Texas Commission on Environmental Quality

Facility Name: Golden Triangle Landfill

Re: NOD Response – Limited Scope Amendment
Golden Triangle Landfill – MSW Permit No. 2027
Jefferson County, Texas
TCEQ Tracking No. 31544963

**SECTION 305.62(j)(2)
LIMITED SCOPE MAJOR PERMIT AMENDMENT
CLASS 1 WASTE ACCEPTANCE RATE AND
OPERATING HOURS CHANGE**

Figure 1
Direct Shear Test In-Situ Waste Shear Strength Summary

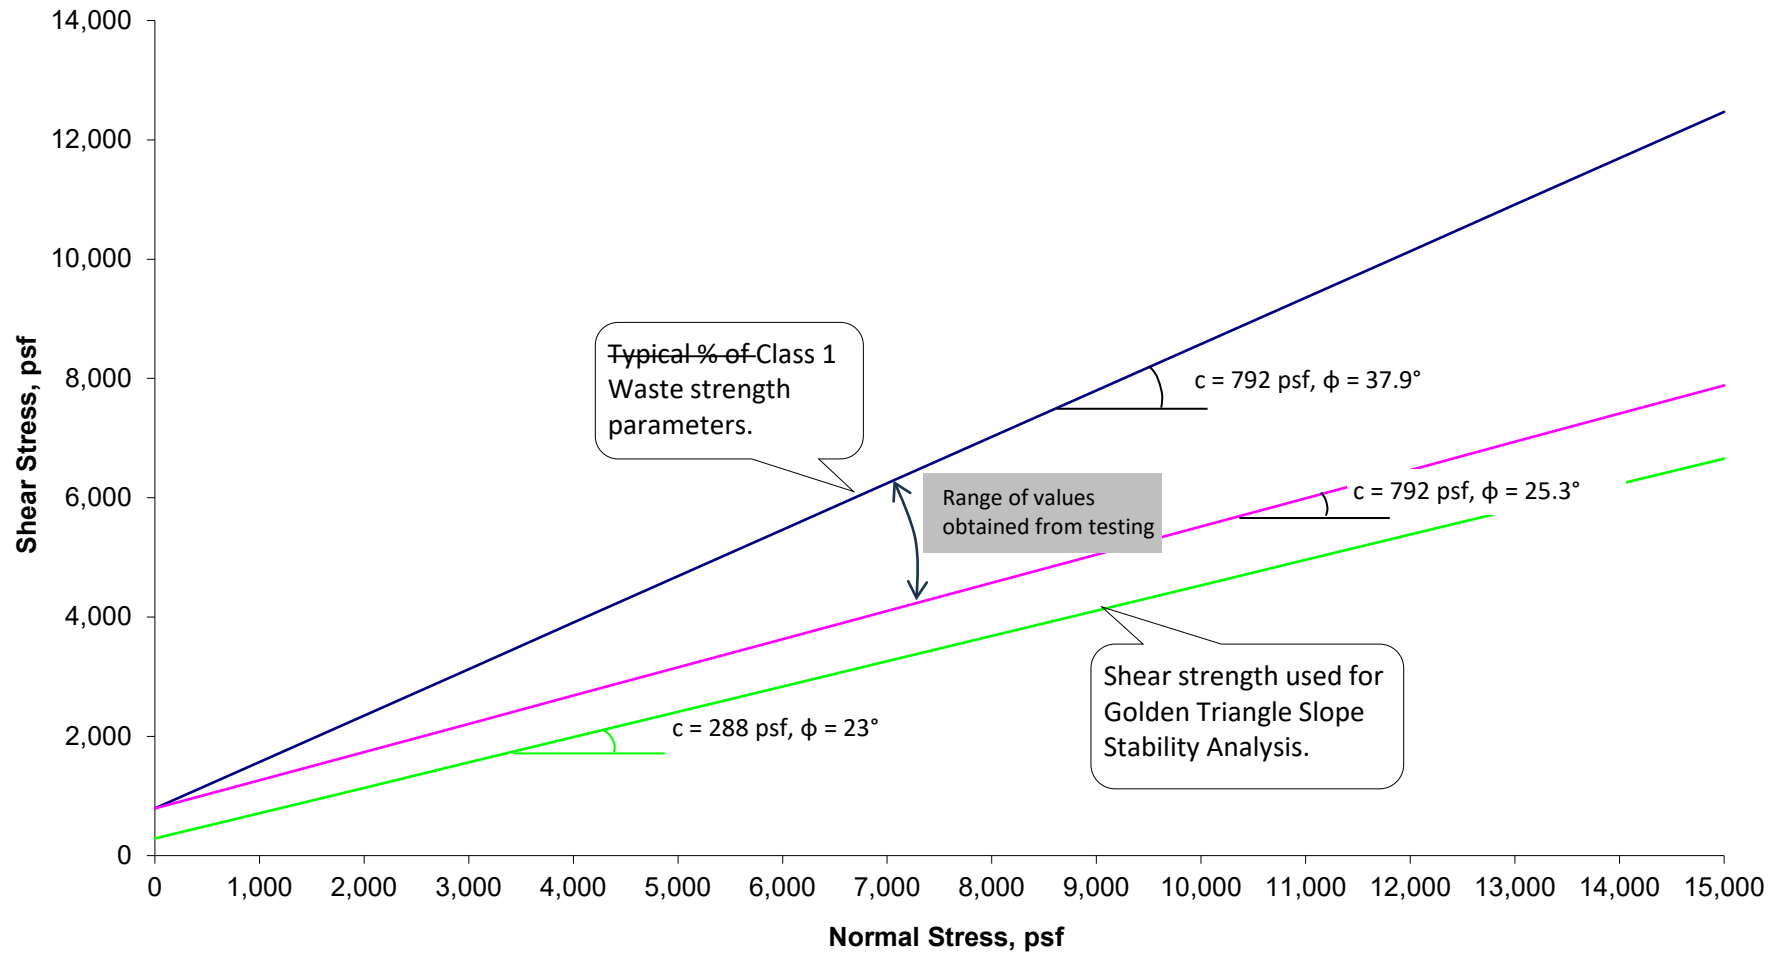
4. **Revise Figure 1 to fix the misalignment of lines.**

9. **Figure 1 shows two lines marked as “Typical % of Class 1 Waste strength parameters.” A third line is referred to as “Shear strength used for Golden Triangle Slope Stability Analysis.” Explain the meaning of “Typical %.” The ranges of the parameter values listed for the first two lines are significantly higher than those for the third line. The parameter values of the third line are the same as listed on Page J-4-3 in the existing SDP and used for Class 1 Waste in the existing slope analysis. Revise Section 4.0 of this application to discuss the validity and relevance of the parameter values listed for the first two lines. Explain why the proposed parameter values are much higher than those used in the existing stability analysis. Also revise other portions of the application as necessary.**

Figure 1 has been updated as requested.

Section 4.0 has been updated to include additional information regarding the shown strength parameter values on Figure 1. Note that “Typical % of” has been removed from Figure 1 (it was inadvertently included). As discussed, the Golden Triangle design utilizes conservative values much lower than typical results seen in previous in-situ testing.
